RE: SCH#2009121079 Joint NEPA/EQA Notice of Completion; draft Environmental Impact Statement / Draft Environmental Impact Report (DEIS/DEIR) for the East County Substation, Tule Wind, and Energia Sierra Juarez Gen-Tie Projects; located in the Jacumba, Manzanita-Boulevard, Campo & Manzanita Indian Reservations Mountain Empire Region about 70 miles east of the City of San Diego; San Diego County, California

**From:** willie.m88@gmail.com [mailto:willie.m88@gmail.com] **On Behalf Of** William Micklin  
**Sent:** Wednesday, January 19, 2011 2:10 PM  
**To:** Greg Thomsen  
**Cc:** Iain Fisher; John Rydzik; jerry.pell@hq.doe.gov; Jesse Bennett; Rica Nitka; Michael Garcia  
**Subject:** DEIR-EIS Setbacks on Tribal Lands

RE: SCH#2009121079 Joint NEPA/CEQA Joint DEIR/DEIS Public Comments  
 for the East County Substation/Tule Wind. Energia Sierra Juarez Gen-Tie Projects

RE: Tule Wind/ECO Substation Draft EIS/EIR

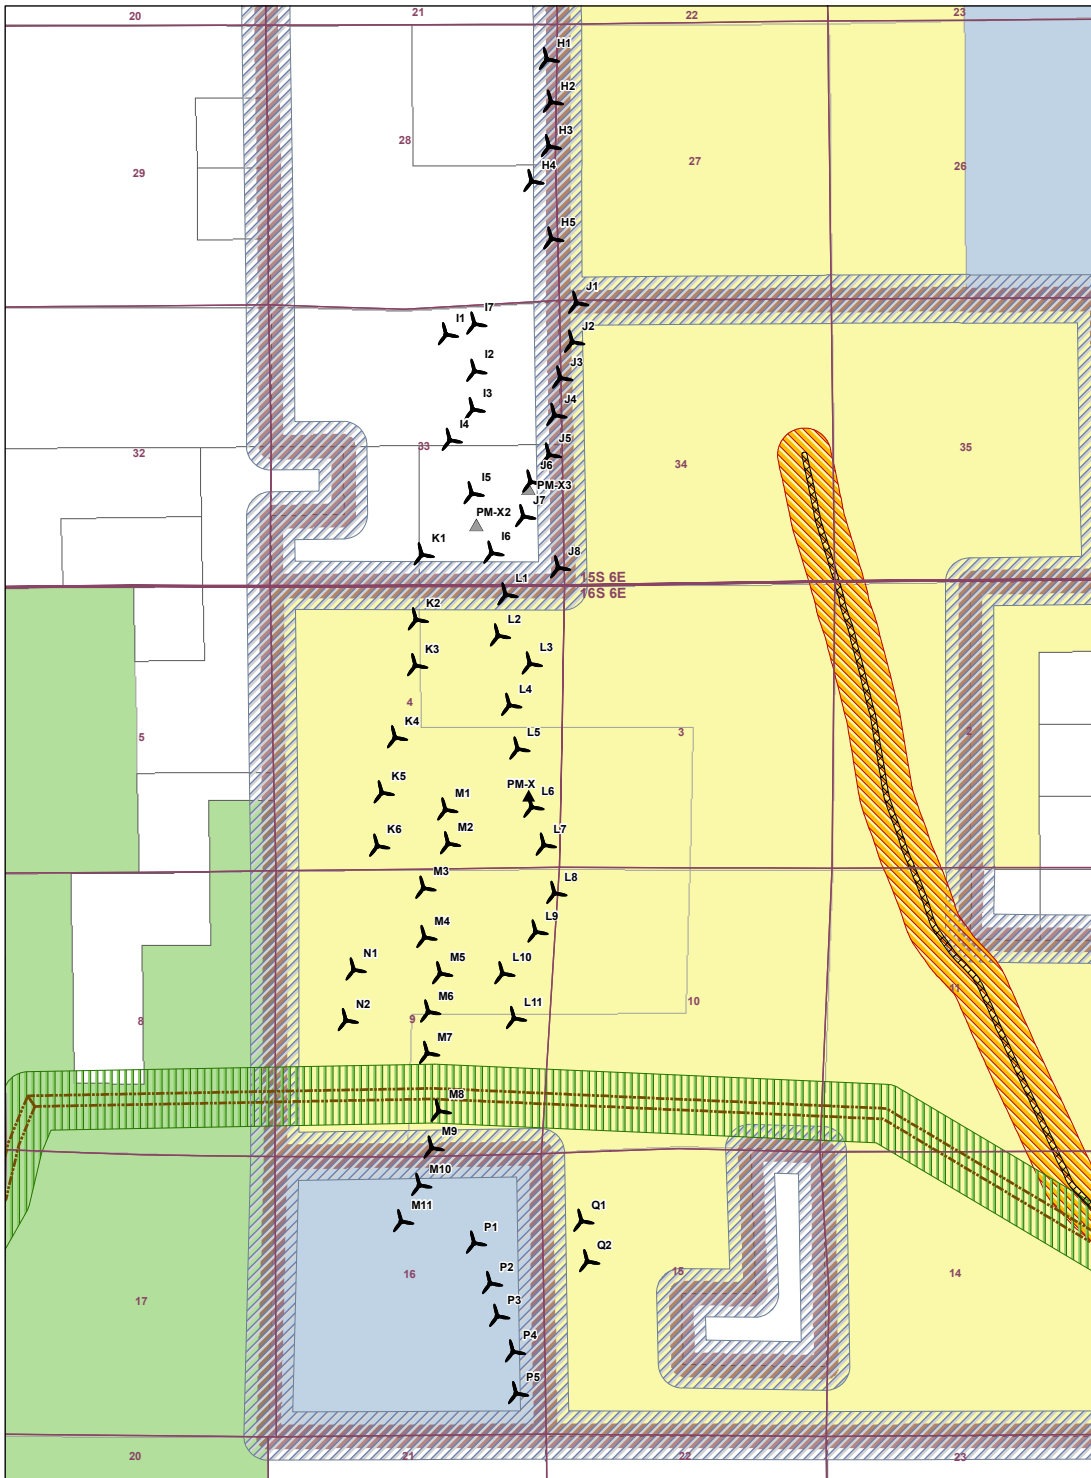
Analysis of the DEIR-EIS for the portion on the Ewiiapaayp Indian Reservation of the Tule Wind Project and the DEIR-EIS recommendations for setbacks (see attachments) shows that the effect of the setbacks would be to eliminate 9 or the 17 turbines on tribal lands. This proposed reduction is unacceptable to the Tribe would occur even if we were to resolve the DEIR-EIS recommendation that all turbines on the tribal lands be eliminated as a conservation restriction to mitigate the potential for take of golden eagles (which is unacceptable to the Tribe as well). Although the setbacks are nominal, because the turbine site locations are on a steep and narrow ridge of the Reservation, any such setback would be impractical and would eliminate the 9 turbines.

**EIR Required Setbacks on the Ridge**  
Tule Wind Project

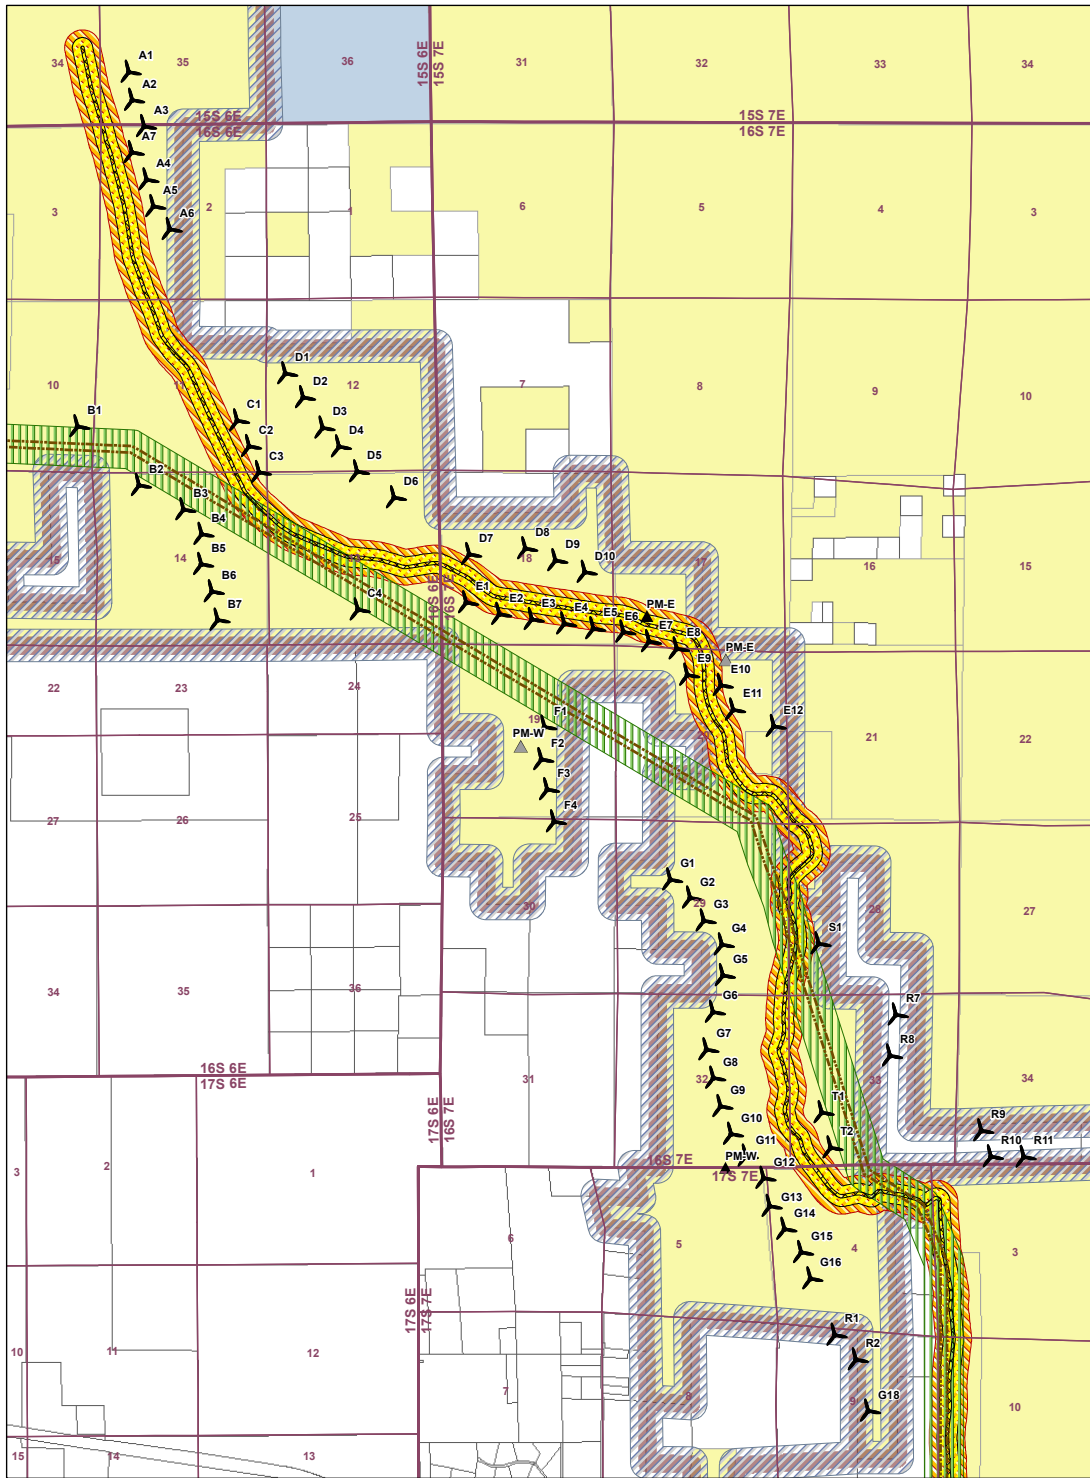
The NEPA environmental analysis has not adequately or reasonably considered the unique governmental rights or interests of the Tribe. The Tribe is requesting the this setback be eliminated for the tribal lands.
